# T ECHNICAL INFORMATION

92700  
March 2012  
(Page 1 of 2)

**Subject** ▶ Addition of Line filter to Endbell complete

**For Models** ▶ BGA402, BGA450, BGA452, BGD800, BGD801, BJS100, BJS101, BJS160, BJS161

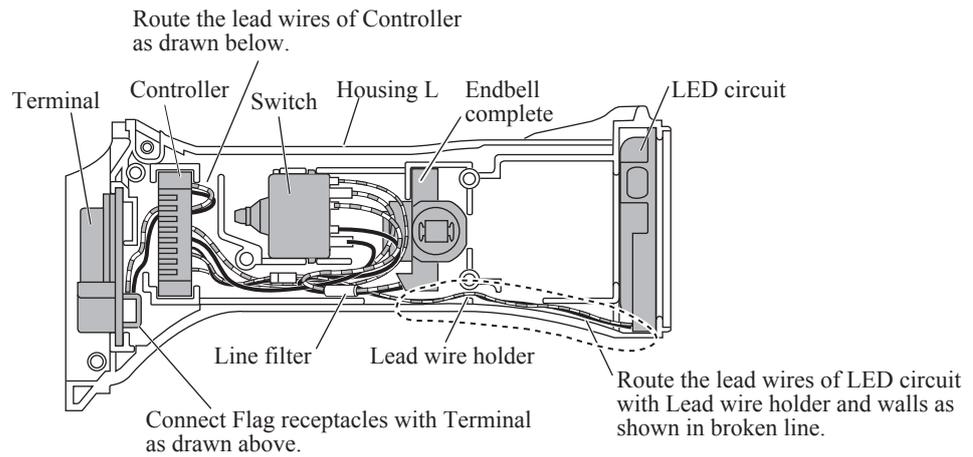
**Description** ▶ To comply with EMC for DC tools:  
 • The lead wires of Endbell complete have been changed in length.  
 • Line filter has been added to the lead wires of Endbell complete.  
 See below and next page for the details.

Item No.	Current part	Q'ty	I/C	New part	Q'ty	Note
See Note.	Endbell complete 638448-2	1	←	Endbell complete 638921-2	1	BGA402, BGA450, BGA452: 033 BGD800, BGD801: 020 BJS100, BJS101, BJS160, BJS161: 041
